**Addendum No. 04**

**File Reference Number: RFP 2025 055**

**Title: North Bay Station Upgrades**

**RE: Clarifications/Questions**

### **Storage Room**

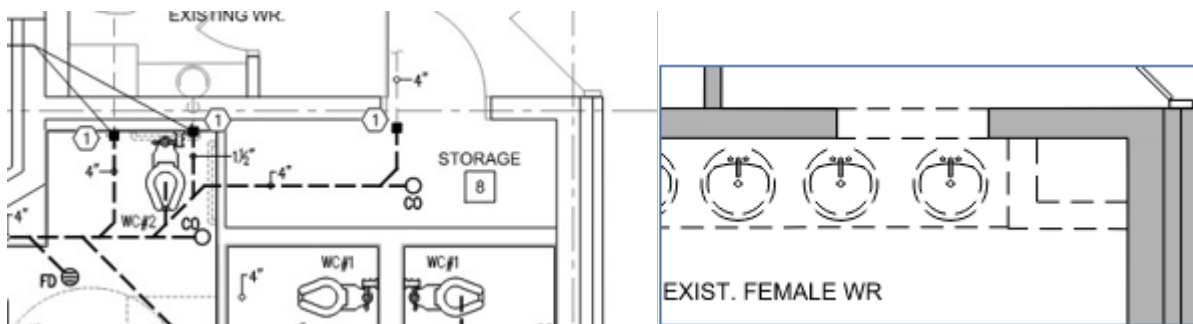
**Item 20:** Storage #7 calls for the existing flooring to remain. This room will be made inside the old washroom area, where the concrete slab will be removed and re-poured to suit the underground plumbing. The corner of the room has a current block wall bump out with no flooring. What type of flooring should be installed in the storage room?

**Answer:** Provide new sheet vinyl flooring and rubber base. Flooring colour to match washrooms.
